WEST CACHE IRRIGATION COMPANY
BUTTARS LATERAL CANAL PIPING PROJECT
ADDENDUM #1

September 15, 2026

ArcGIS Web Map

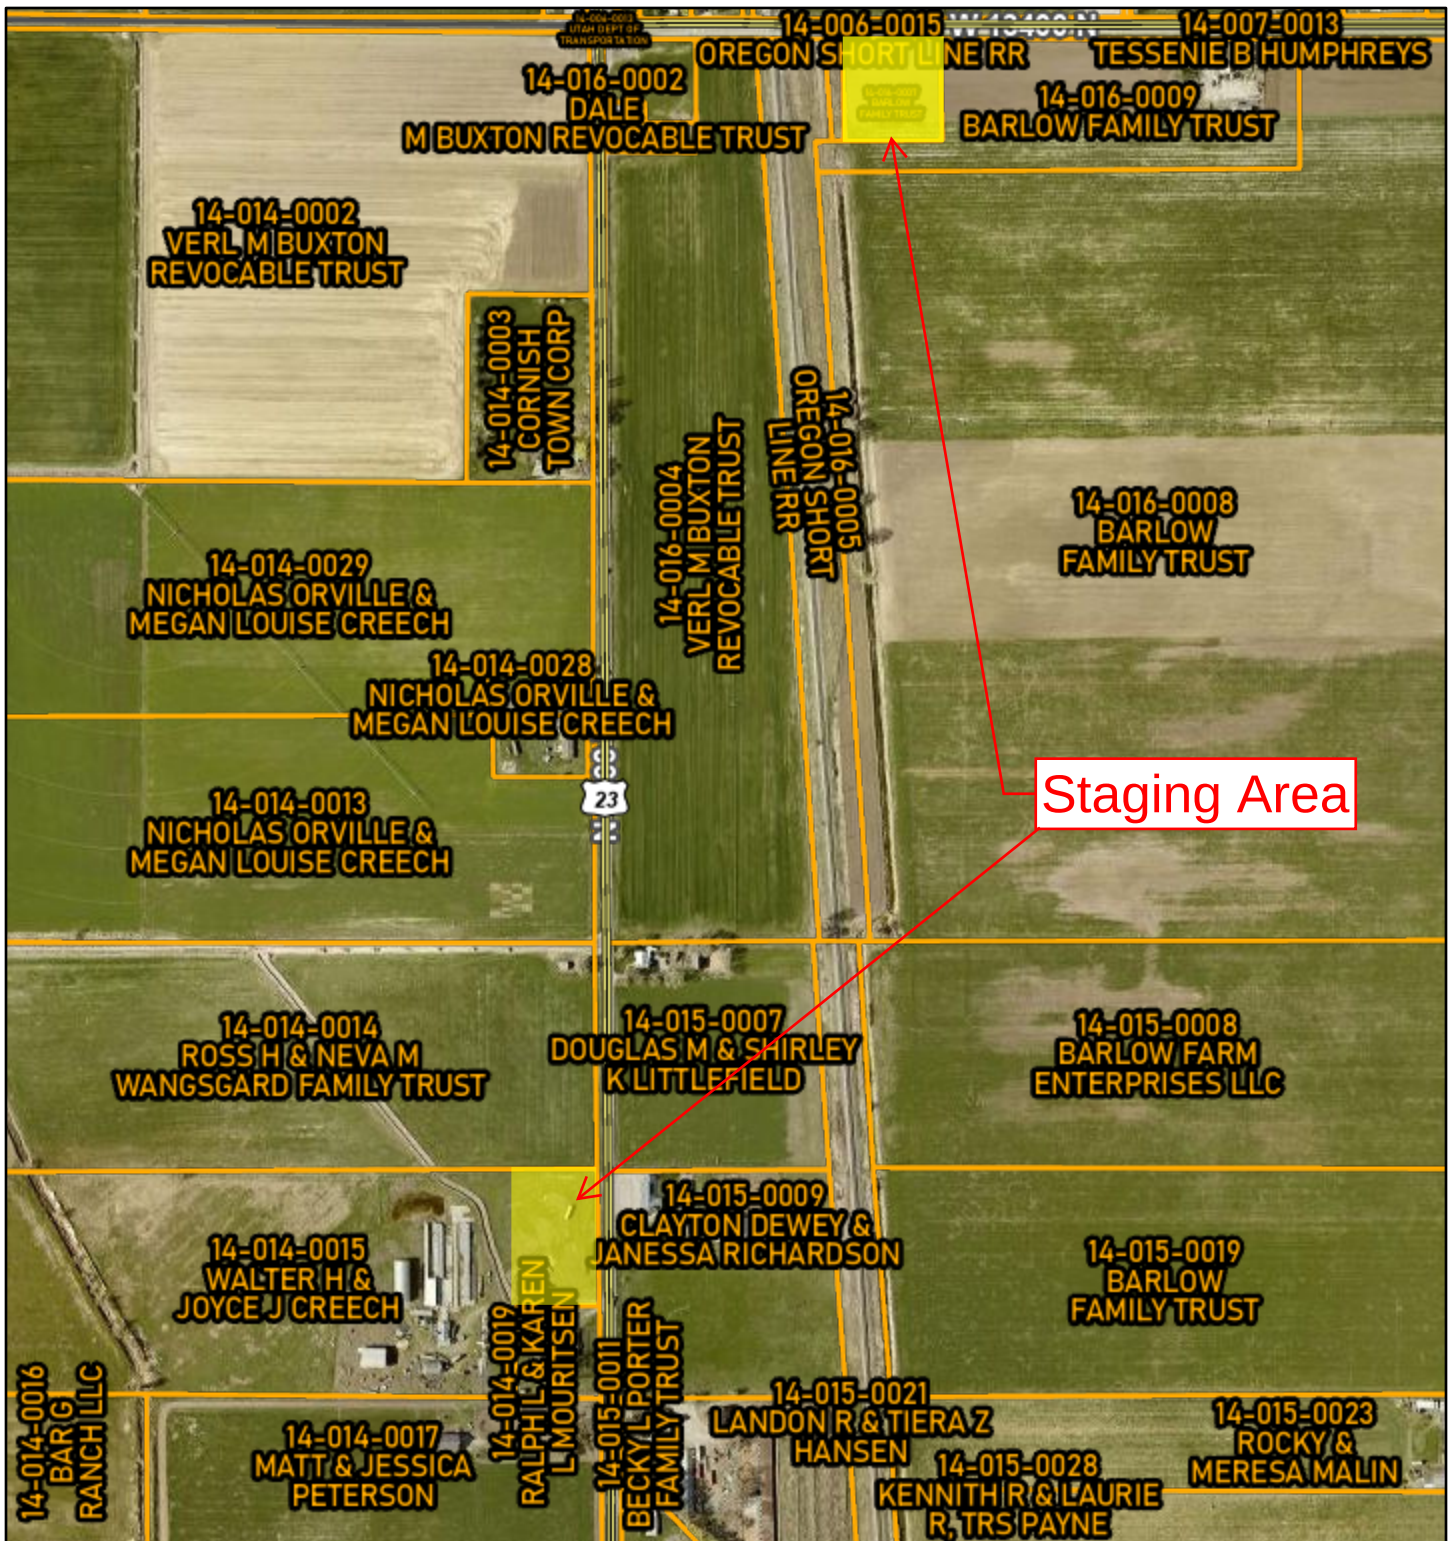
The staging area identified on Plan Sheet GN6, located on Parcel #14-014-0006, owned by the Floyd & Jeanene Viebell Family Trust, will not be used. Alternatively, Parcel #14-016-0001, owned by the Dale M. Buxton Revocable Trust, and the eastern portion of Parcel #14-014-0015, owned by Walter H. & Joyce J. Creech, will be used for construction staging. The revised Staging Area Exhibit is attached to this Addendum #1.

A: Revised staging areas are shown on an exhibit attached to this Addendum. The staging location originally shown in the Plan Sheet GN6 shall not be used unless separately authorized by the Owner and Engineer. The Contractor shall remain within the approved staging and access limits.
